Service Kit 759-04142

Date: 11/21/2006

Subject: Service Replacement for the 42" RZT Left Hand (LH) Hydro Transmission.

(See Figure 1)

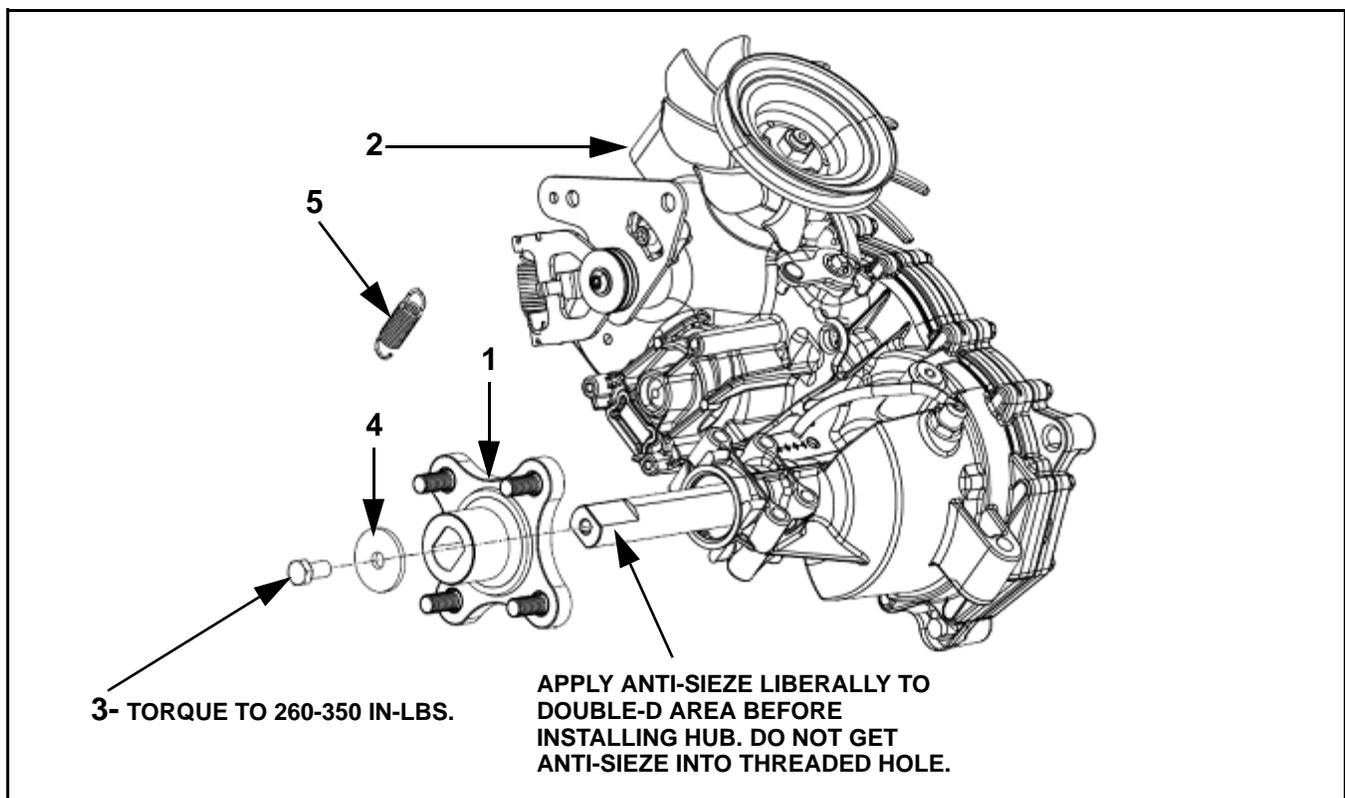
PURPOSE: This service kit replaces the LH hydro transmissions 618-04164A and 618-04327 which are no longer available. The replacement transmission has a Double-D axle end which requires a Double-D wheel hub assembly. A new neutral return spring is enclosed for the RH transmission. See instructions on page 2 of this sheet.

ITEM NO.	PART NUMBER	QTY	DESCRIPTION
1	618-04494	1	HUB ASM:WHL:DOUBLE-D SHORT
2	618-04431B	1	TRANS ASM:HYDRO:EZT:LH
3	710-3119	1	SCREW:3/8"-16 x .750:GR5:LOCK
4	736-0227	1	WASHER:FLAT: .390 x 1.50 x .134
5	732-04448	1	SPRING: EXTENSION (See page 2)
	*	1	THIS INSTRUCTION SHEET

FIGURE 2

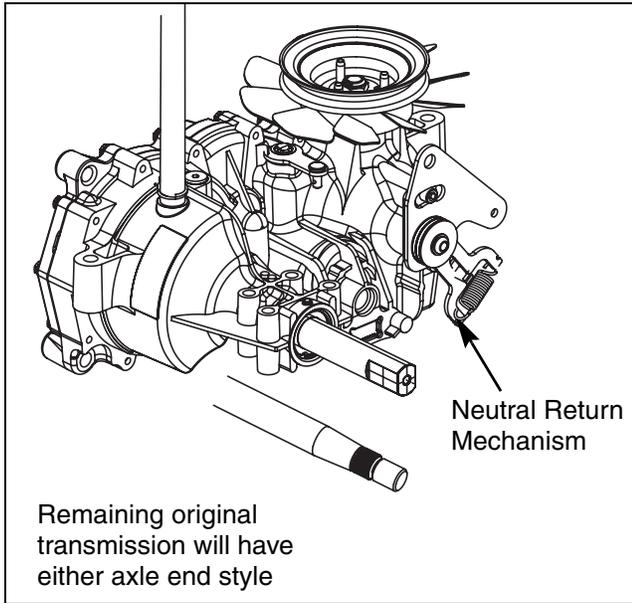
3. See Figure 2 for location of the neutral return mechanism.

FIGURE 3

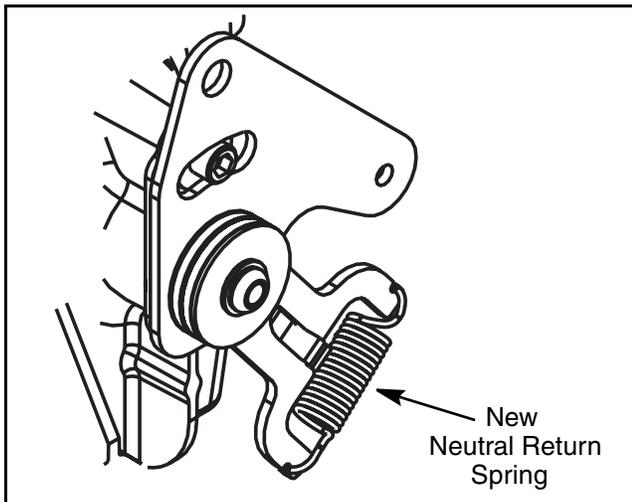
5. Install the new Neutral Return Spring, Item 5, onto the two arms as shown in Figure 3.

6. When complete both installed transmissions must have the same color neutral return spring.

4. With a suitable set of pliers or spring removal tool, remove and discard the existing spring from the neutral return mechanisms two arms on the remaining (not replaced with this kit) hydrostatic transmission. See Figure 3.
